Glendell Mine Modification 4

RESPONSE TO SUBMISSIONS

May 2019

Project Director: Bret Jenkins
Project Manager: Penelope Williams
Report No. 4052/R11
Date: May 2019

FIGURE 5.1

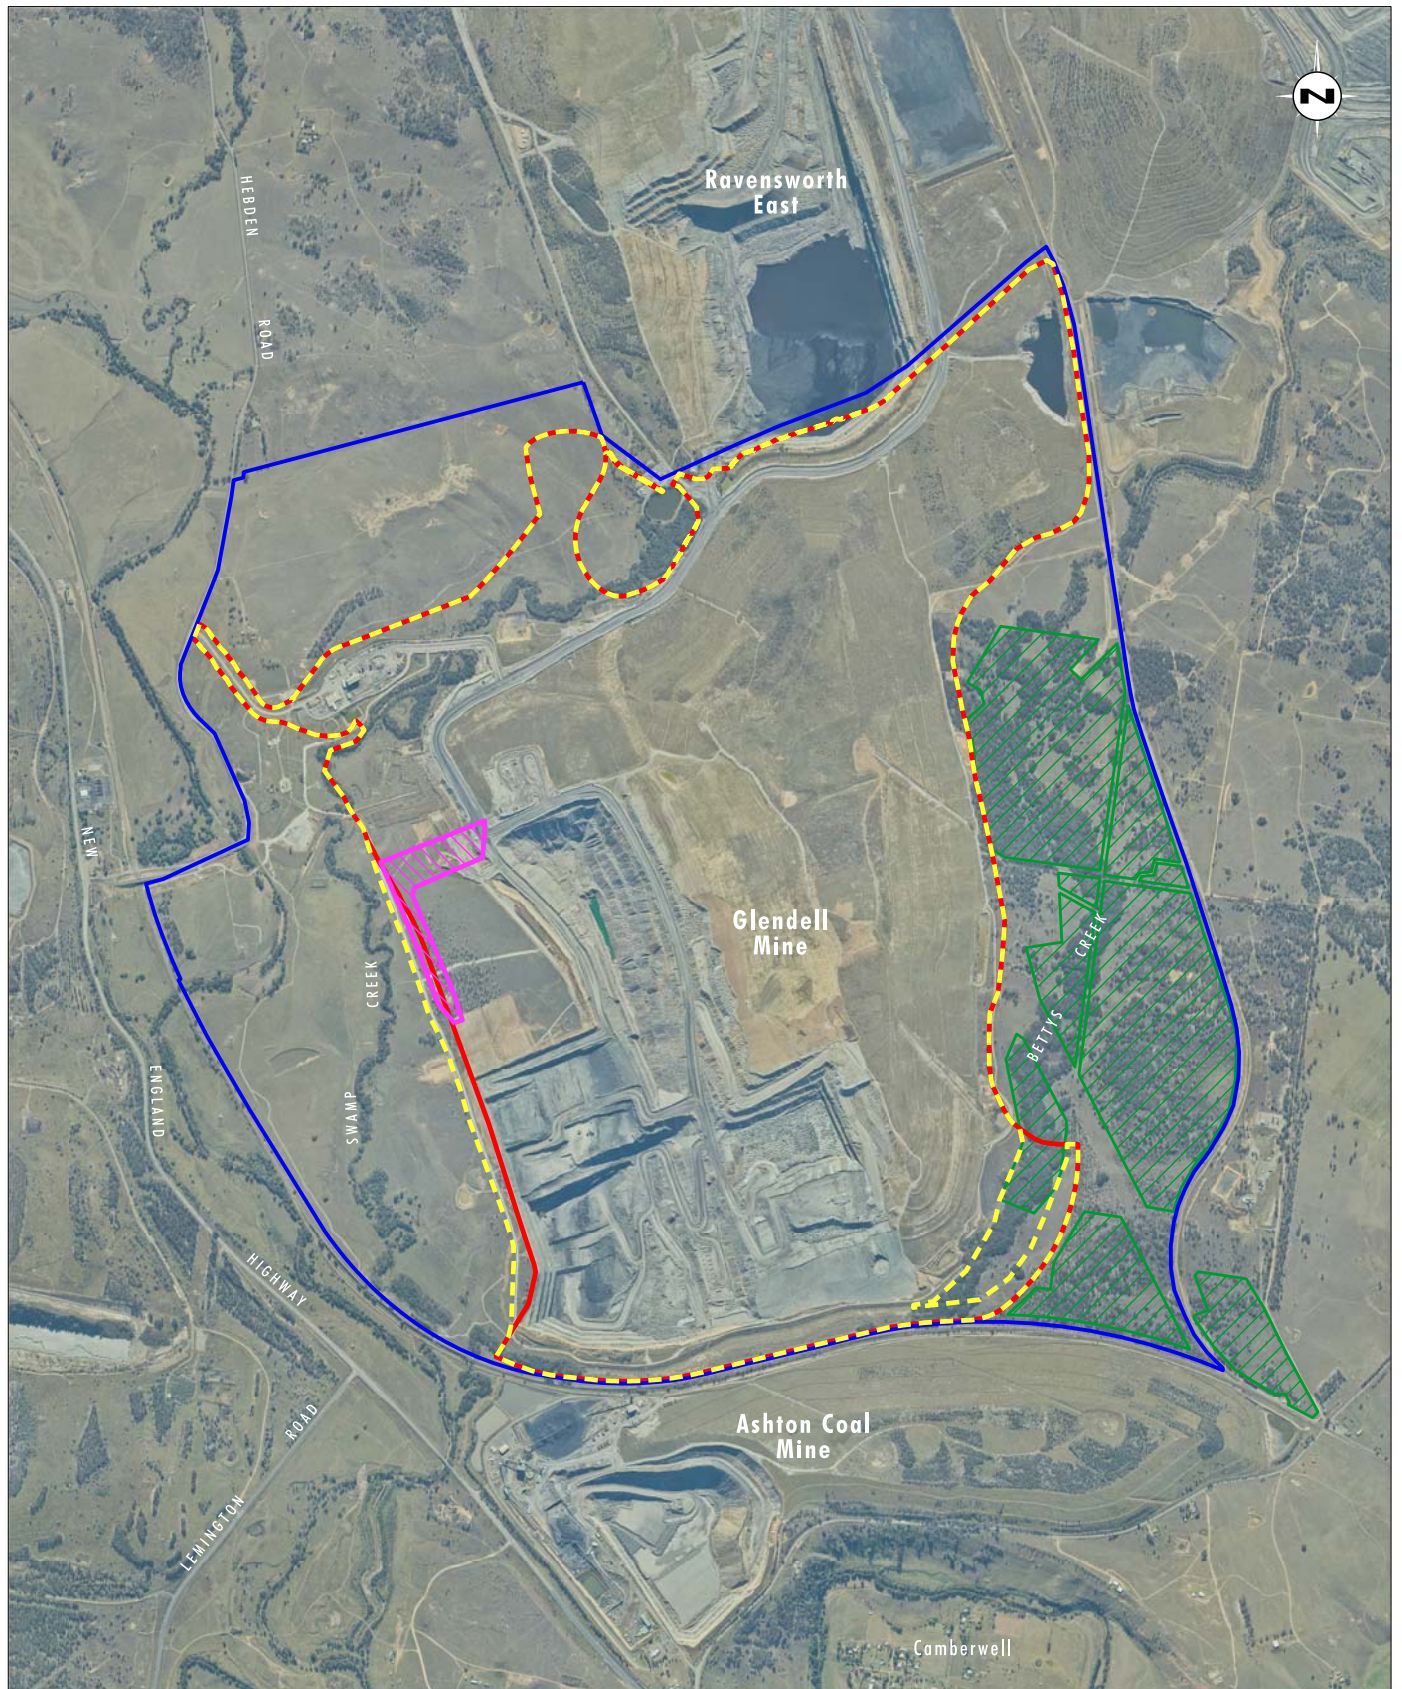
This area has now been reduced from 15.5 to 7.7 ha, the Proposed Modification will therefore result in a net increase of 4.3 ha in the overall disturbance area, refer to **Figure 5.1**.

FIGURE 6.1

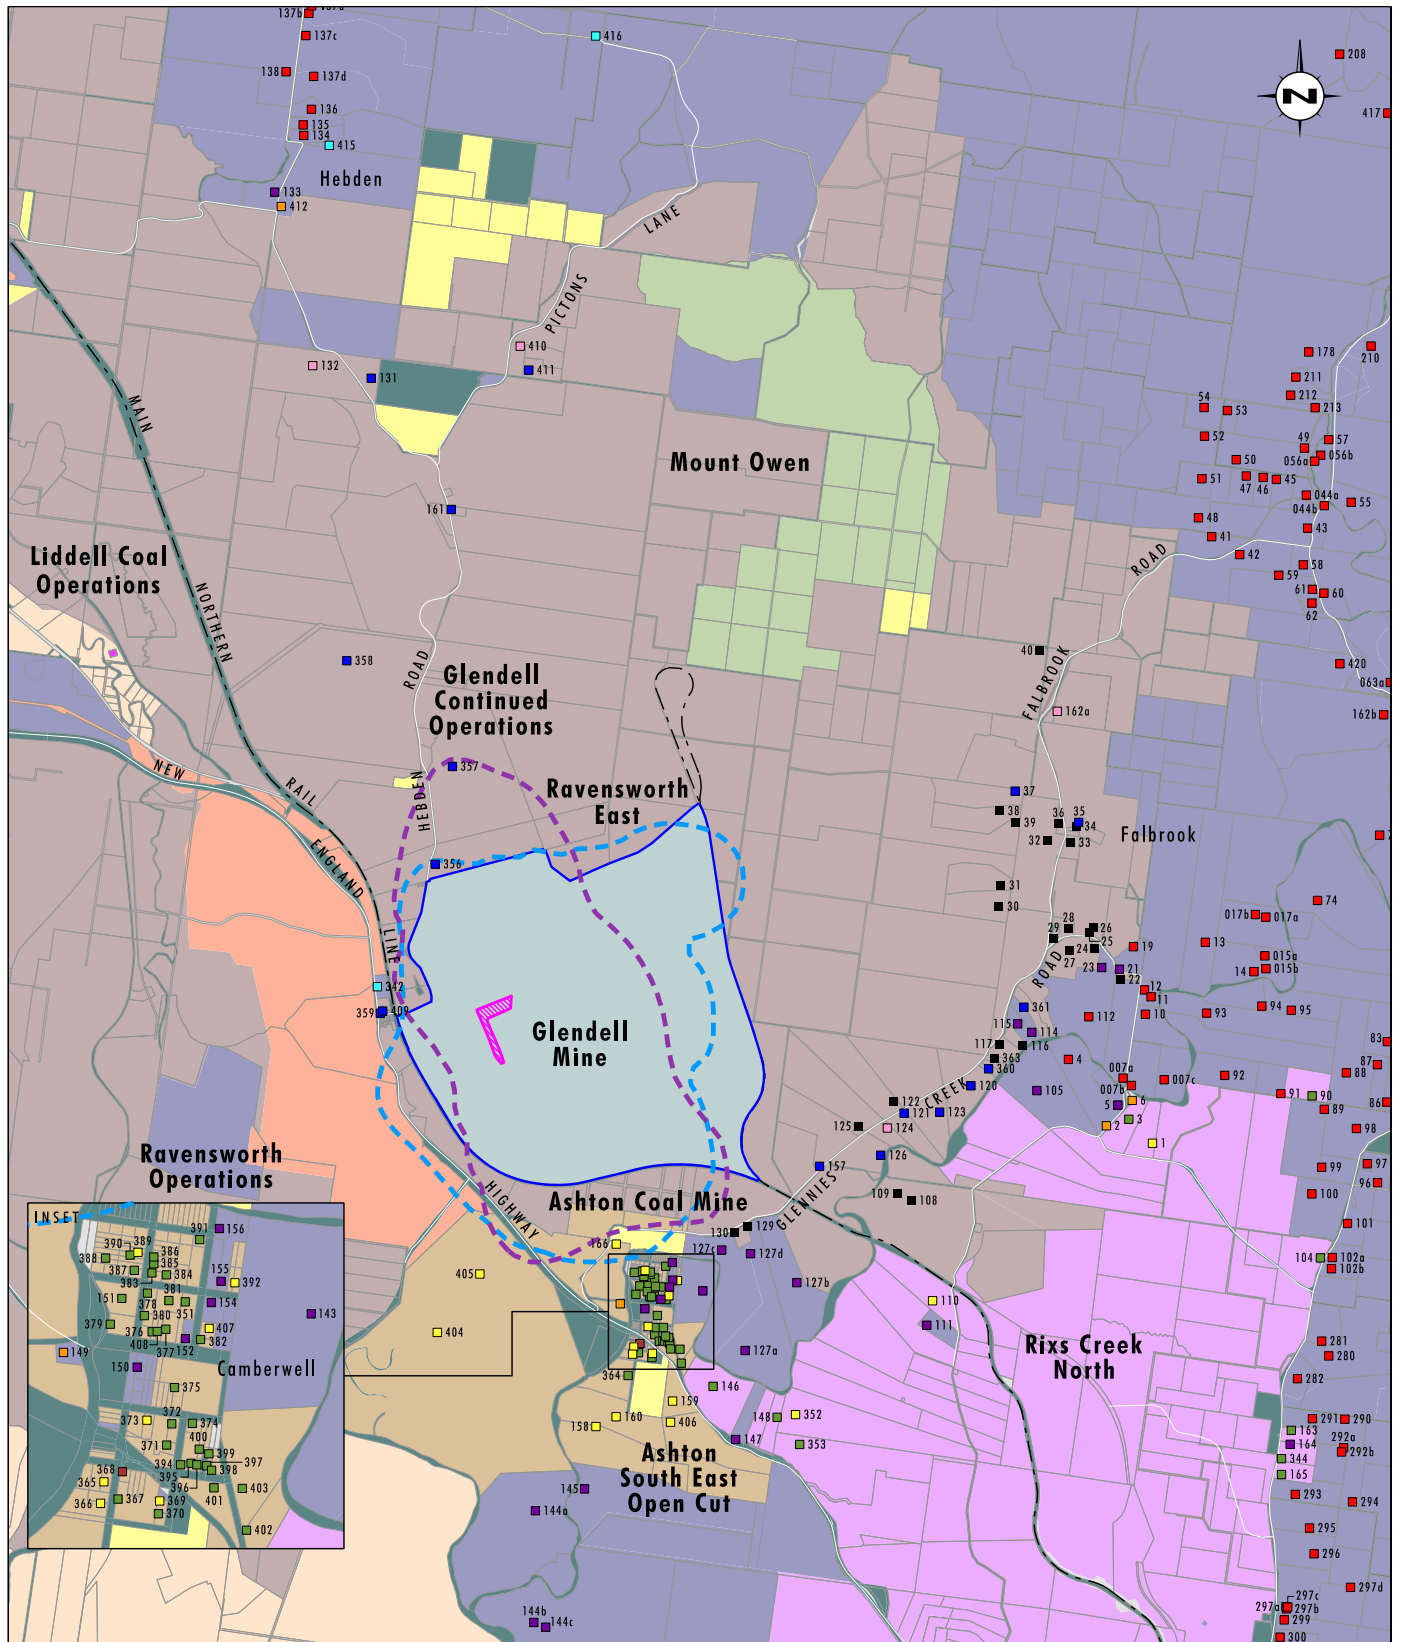
Modelling predictions indicate a reduced contribution from Glendell Mine to maximum 24-hour PM₁₀ concentrations in the Camberwell area, relative to the Approved Operations. There is a potential increase in maximum contributions to the north of Glendell Mine, most likely attributed to the progression of mining to the north, however the changes are predicted in an area where there are no private sensitive receptors, refer to **Figure 6.1**.

FIGURE 6.2

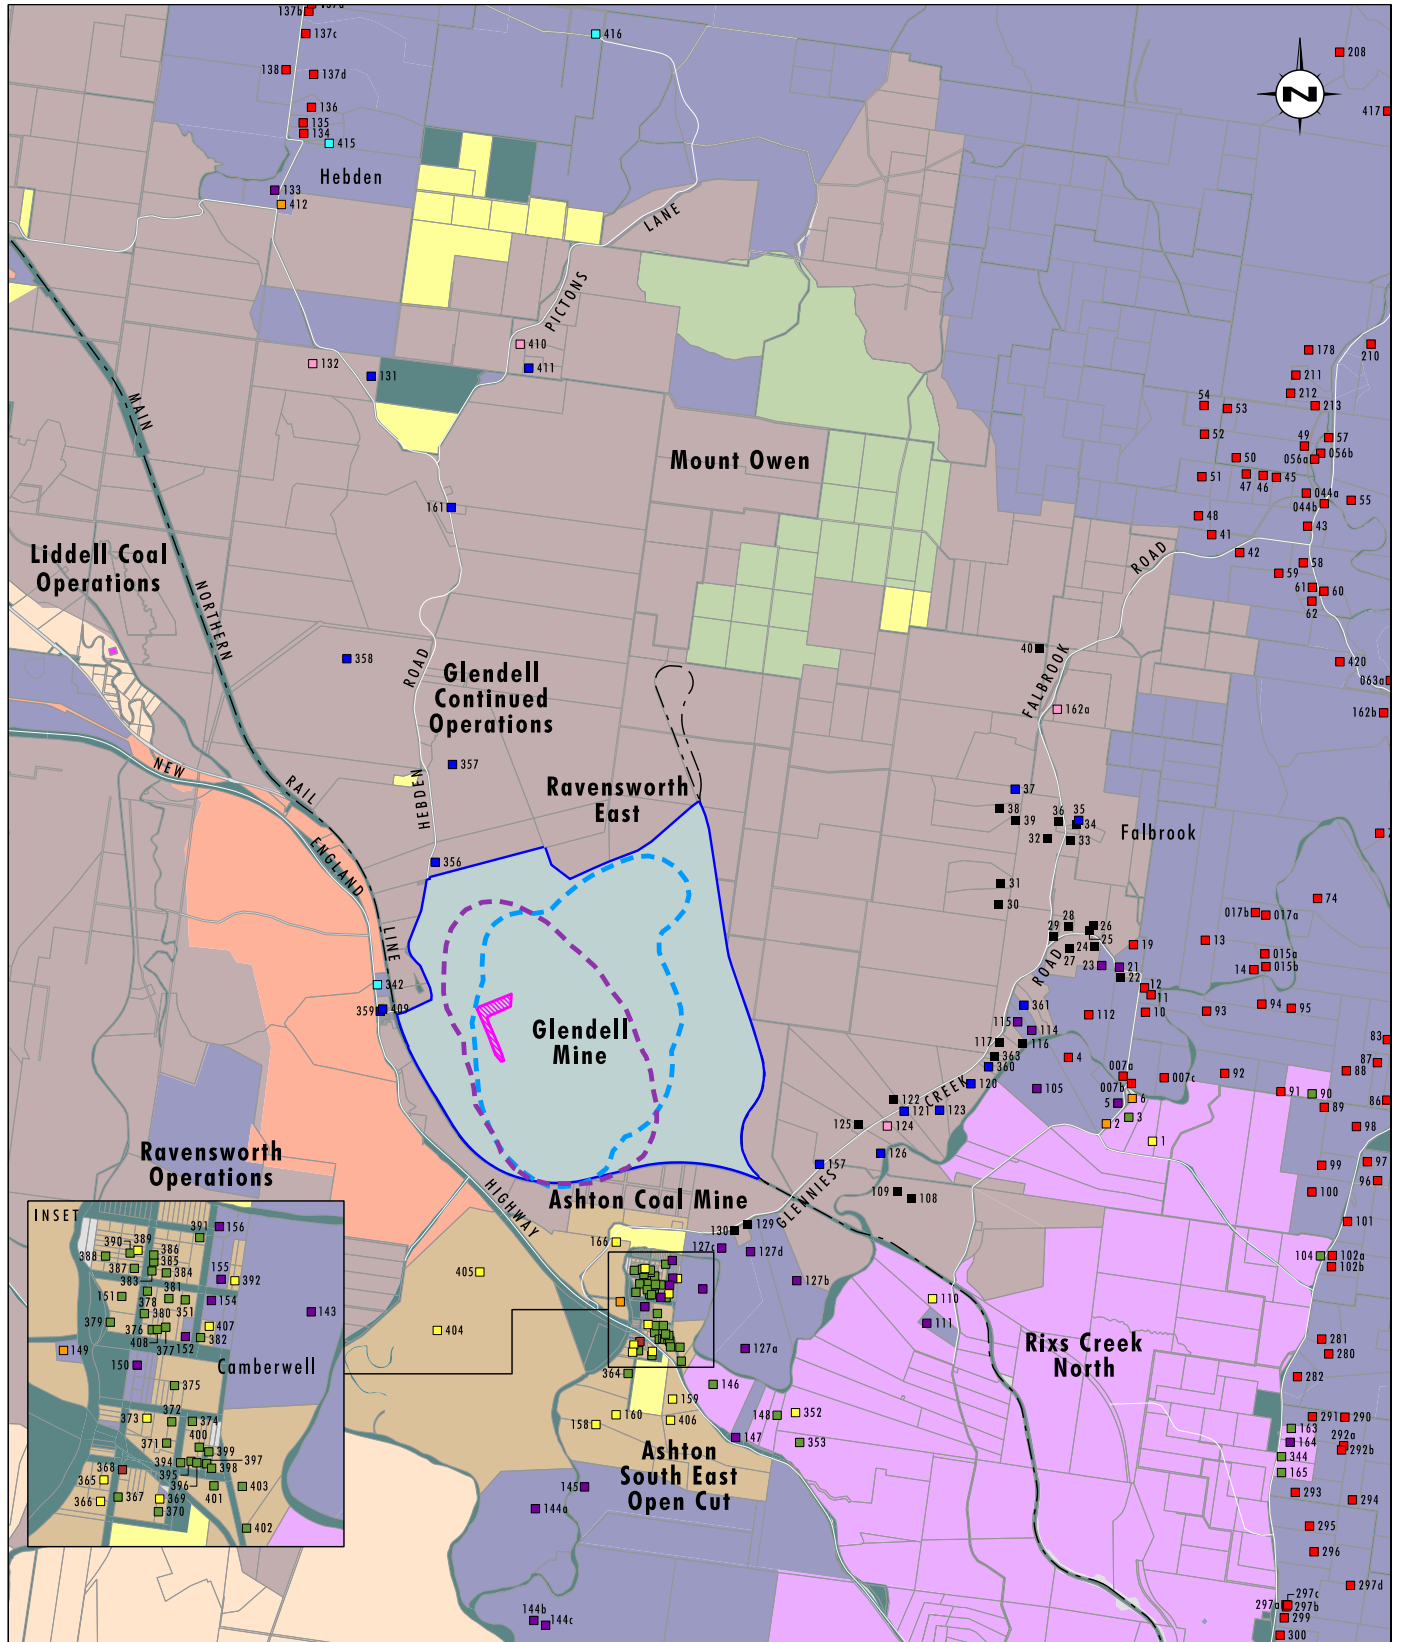
The extent of the annual average 25 µg/m³ contour in the vicinity of the Camberwell area is almost identical for the Approved Operations and Proposed Modification scenarios and, from an air quality perspective, these results would suggest a negligible change in air quality, refer to **Figure 6.2**.
